Access Compliance Report Public Rights-of-Way (Curb Ramps)

Main Street: O_NEILL_DR		Cross Street: CECIL_PASTURE_RD		Location:	SW
ADA ID: RPRK211025143015	Ramp Type: Type 4 - Parallel	Initial Pass/Fail: Fail	Overall Compliance: No	Severity Score:	15
Codes/Mitigation Info/Possible Solution			Field Measurements/Component Compliance

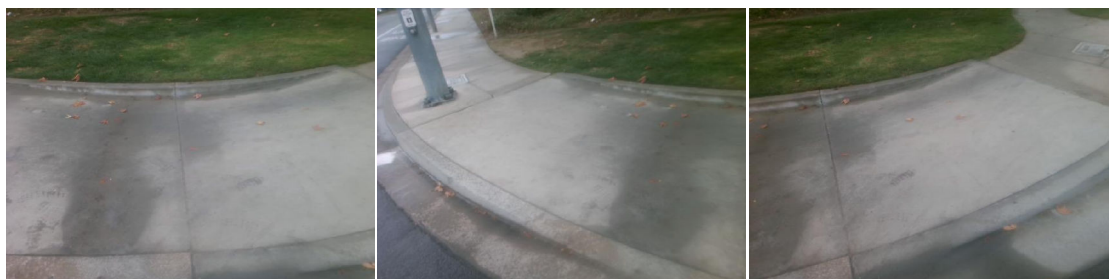
R204.3, R304.3.2, STD 1115

Remove & Replace Curb Ramp With Two New Directional Ramps or Equivalent.
